Product Change Notification / NTDO-21XSFE180

CCB 4853 Final Notice: Qualification of MMT as an additional assembly site for selected Atmel ATMEGA324PB device family available in 44L VQFN (7x7x1mm) package using CuPdAu wire.

CCB 4853
Pre and Post Change Summary
PCN # NTDO-21XSFE180

Lead frame Comparison

Pre Change ASCL

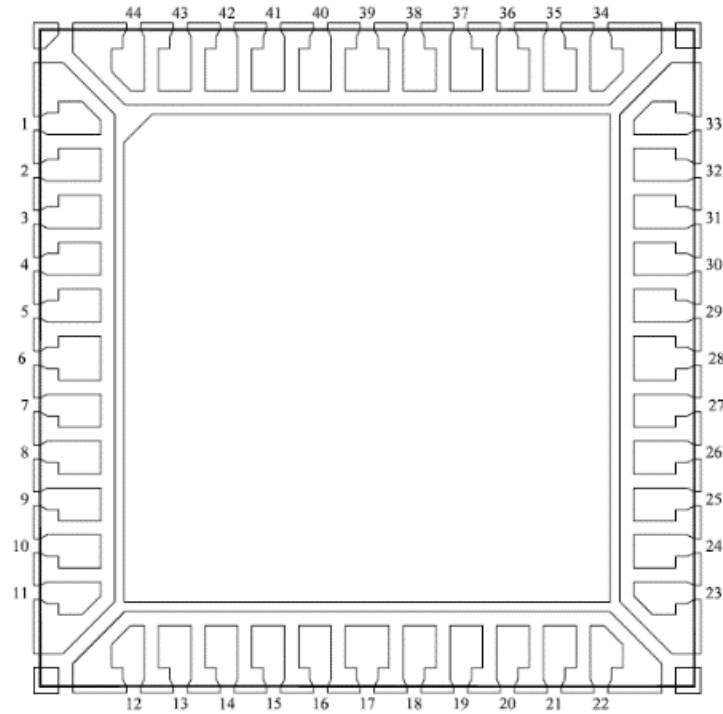
MSL Information		MSL 3
Wire material		CuPdAu / Cu
Die attach material		EN-4900G
Molding compound material		G700LA
Lead frame	Material	C194
	Paddle size	213x213 mils
	DAP Surface Prep	Bare Cu

Post Change MMT

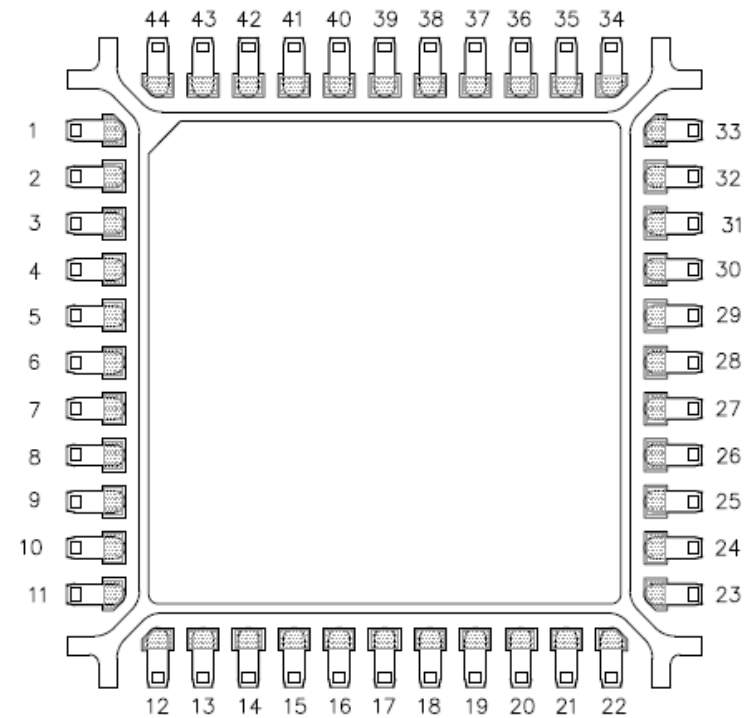
MSL Information		MSL 1
Wire material		CuPdAu
Die attach material		3280
Molding compound material		G700LTD
Lead frame	Material	C194
	Paddle size	213x213 mils
	DAP Surface Prep	Bare Cu
